Our reference: SDA-0117-036553

Amended Concurrence agency response—with conditions

Material change of use for a caravan park on land situated at Captain Cook Highway, Port Douglas and described as Lot 45 on SR835.

PLANS AND DOCUMENTS
referred to in the
DEVELOPMENT APPROVAL
Approval no: SDA-0117-036553

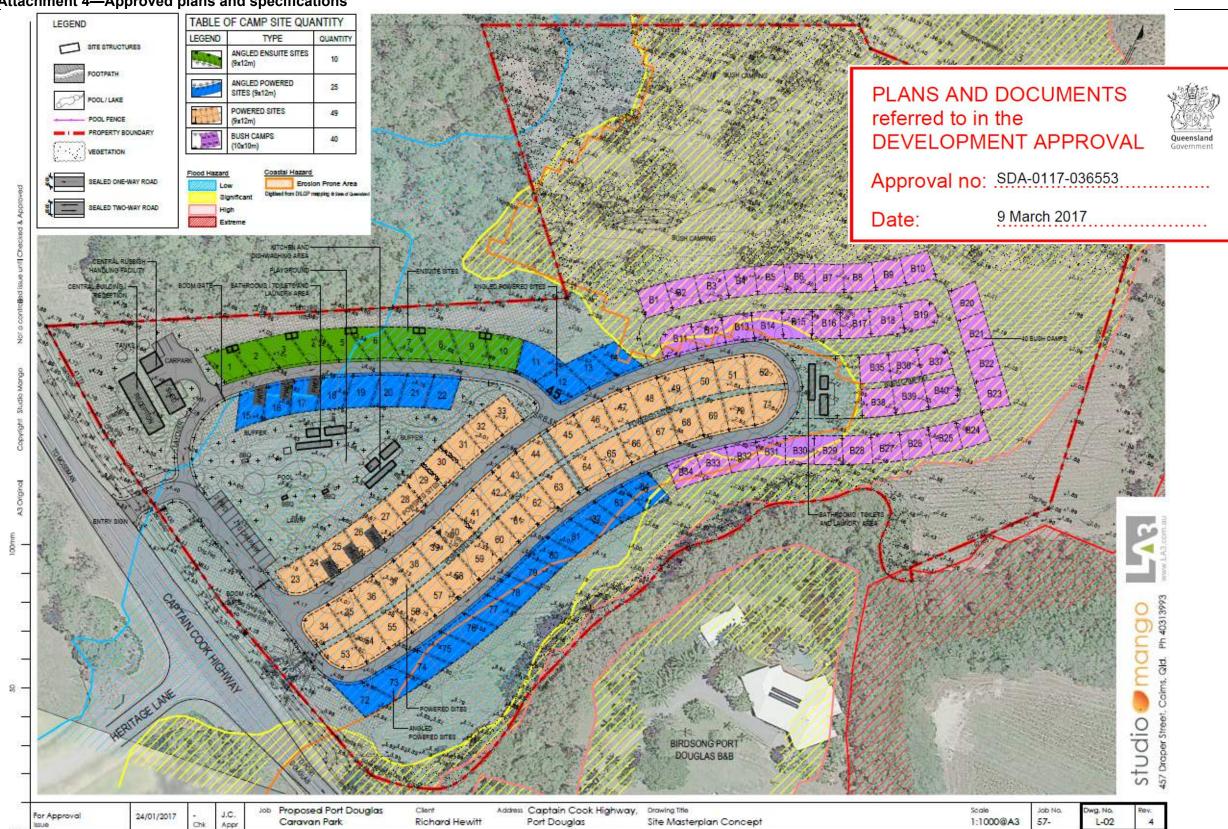
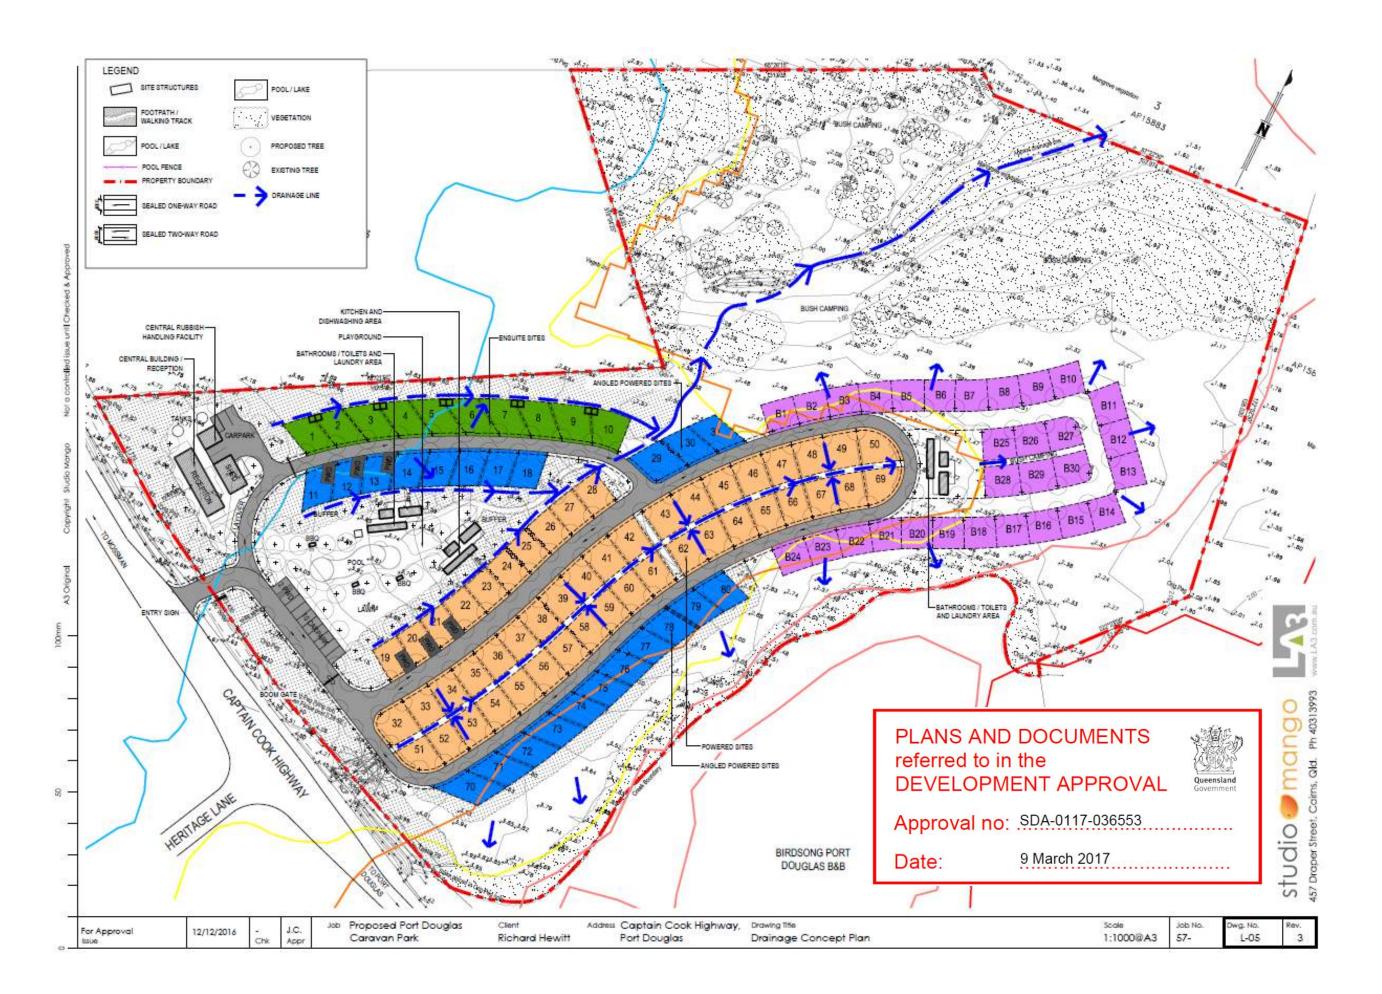
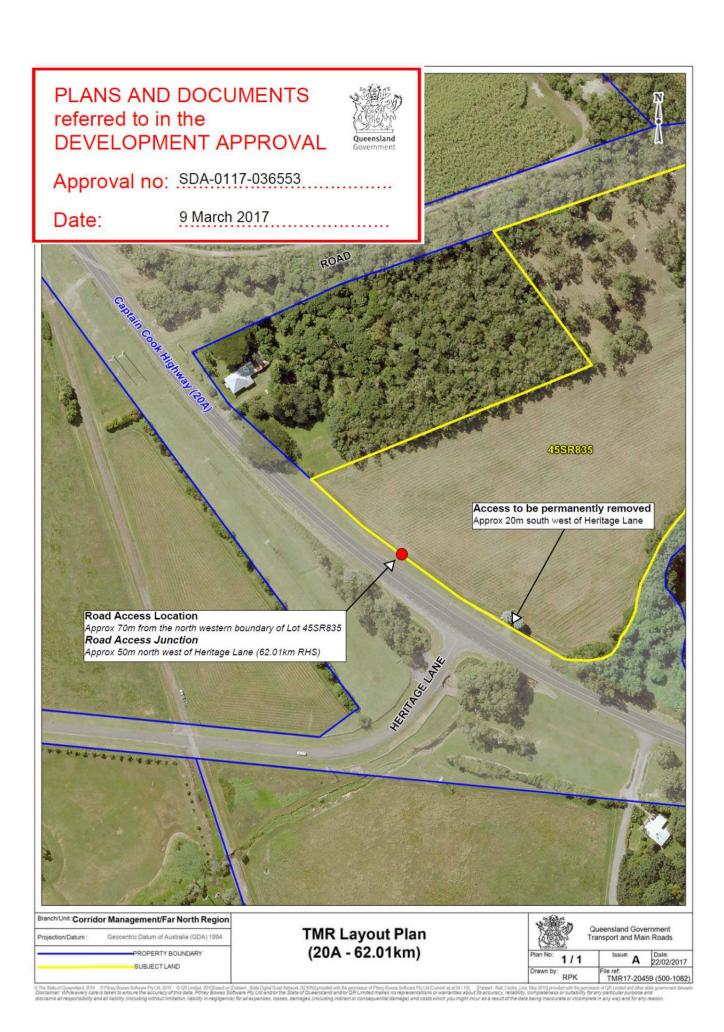
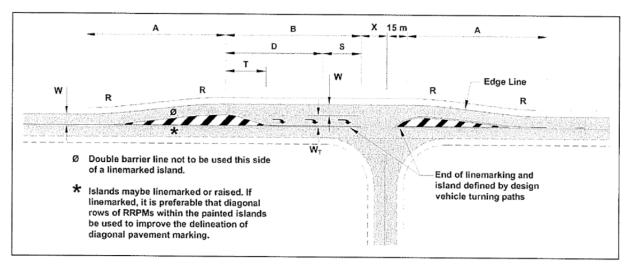
No.	Conditions	Condition timing
Mate	rial change of use	
Planr Depa which	Indule 7, Table 3, Item 1 – State-controlled road —Pursuant to section 255D aing Act 2009, the chief executive administering the Act nominates the Direct artment of Transport and Main Roads to be the assessing authority for the in this development approval relates for the administration and enforcementing to the following condition(s):	ctor-General of e development to
In ac	cordance with approved plans	
1	 The development must be carried out generally in accordance with the following plans: Site Masterplan Concept prepared by Studio Mango, dated 12/12/2016, Dwg No. L-02 and Rev 3. Site Masterplan Concept prepared by Studio Mango, dated 24/01/2017, Dwg No. L-02 and Rev 4. Drainage Concept Plan prepared by Studio Mango, dated 12/12/2016, Dwg No. L-05 and Rev 3. TMR Layout Plan (20A - 62.01km) prepared by Queensland Government Transport and Main Roads, dated 22/02/2017, Reference TMR17-20459 (500-1082), Issue A. 	Prior to the commencement of use and to be maintained at all times.

Vehic	cular access to the state-controlled road	
2	The road access location is to be located generally in accordance with TMR Layout Plan (20A - 62.01km) prepared by Queensland Government Transport and Main Roads, dated 22/02/2017, Reference TMR17-20459 (500-1082), Issue A.	Prior to the commencement of use and to be maintained at all times.
Road	l works on a state-controlled road	
3	 (a) Roadworks comprising of a Channelized Right-turn (CHR) treatment, a Rural Auxiliary Left-turn (AUL) treatment and Category V5 Lighting must be provided at the road access location. (b) The roadworks must be designed and constructed in accordance with: Austroads Guide to Road Design: Part 4A Unsignalised and 	Prior to the commencement of use.
	Signalised Intersections, dated 2010. Figure 7.7: Channelised right-turn (CHR) on a two-lane rural road, and Figure 8.4: Auxiliary left-turn treatment (AUL) on a rural road. The Department of Main Roads Road Planning and Design Manual

Figure 8.4: Auxiliary left-turn treatment (AUL) on a rural road

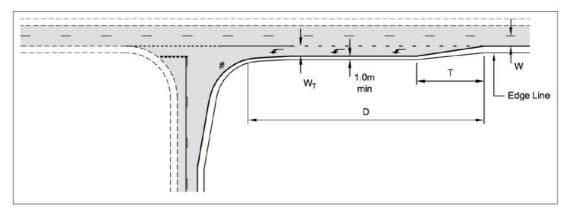
Department of Transport and Main Roads note: Site specific requirements may not reflect this example in its entirety. Detailed drawings will be issued upon application for Road Works / Road Access Works.
